# Product Change Notification (PCN)

PCN #: 11B-2021 DATE: 25<sup>th</sup> November 2021

Laird Part Number	Description
455-00006	Kit, Sentrius IG60-SERIAL Gateway, Laird Linux
455-00008	Kit, Sentrius IG60-SERIAL Gateway, AWS IoT Greengrass
455-00076	Kit, Sentrius IG60-BL654 Gateway, Laird Linux
455-00081	Kit, Sentrius IG60-BL654 Gateway, AWS IoT Greengrass
455-00084	Kit, Sentrius IG60-SERIAL-LTE Gateway, Laird Linux
455-00085	Kit, Sentrius IG60-SERIAL-LTE Gateway, AWS IoT Greengrass
455-00088	Kit, Sentrius IG60-BL654-LTE Gateway, Laird Linux
455-00089	Kit, Sentrius IG60-BL654-LTE Gateway, AWS IoT Greengrass
455-00118	Kit, Sentrius IG60-BL654-LTE Gateway, AWS IoT Greengrass, ASB
455-00113	Kit, Sentrius IG60-BL654 Gateway + BT510 Starter Kit, AWS IoT Greengrass, Packaging
455-00114	Kit, Sentrius IG60-BL654-LTE Gateway + BT510 Starter Kit, AWS IoT Greengrass

## 5.1 Back Product Label (on device)

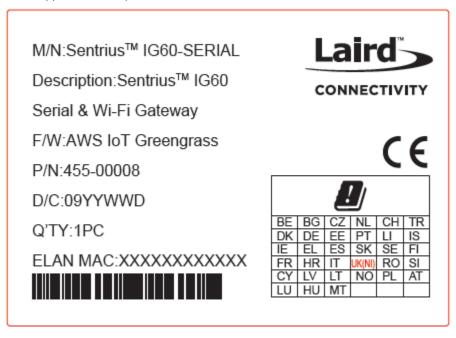
Addition of UKCA logo on the back product label, where it can be accommodated.
